Platform Electrical 2023
08/26/23

Platform Electrical 22 Rev 5 Drawn by: Ted Dunn
2/28/23 Approved by: *[Signature]*

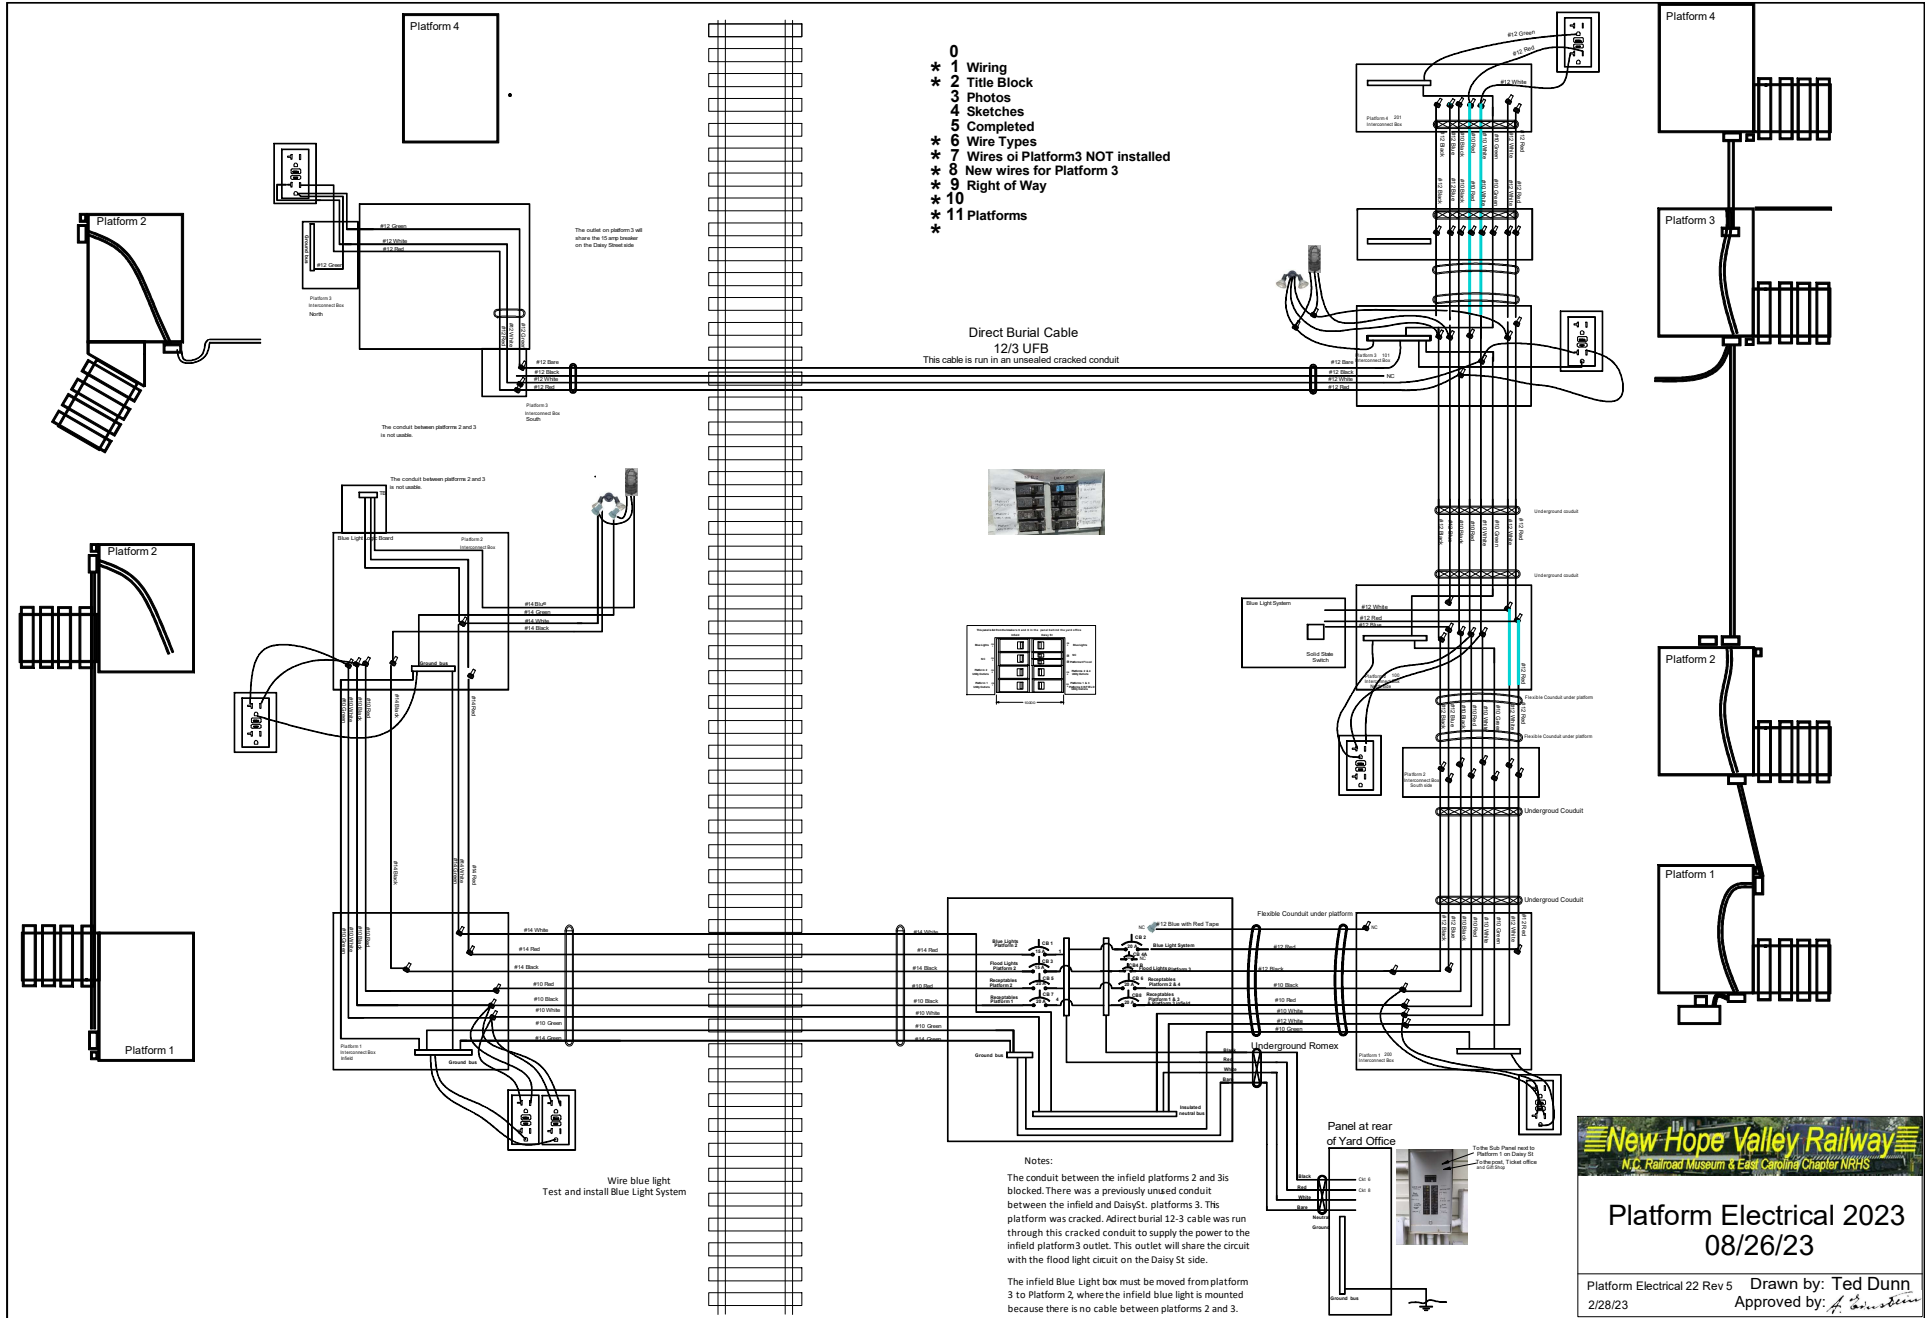
Direct Burial Cable
12/3 UFB
This cable is run in an unsealed cracked conduit

Wire blue light
Test and install Blue Light System

The conduit between the infield platforms 2 and 3 is blocked. There was a previously unused conduit between the infield and Daisy St. platforms 3. This platform was cracked. Adirect burial 12-3 cable was run through this cracked conduit to supply the power to the infield platform 3 outlet. This outlet will share the circuit with the flood light circuit on the Daisy St side.

The infield Blue Light box must be moved from platform 3 to Platform 2, where the infield blue light is mounted because there is no cable between platforms 2 and 3.
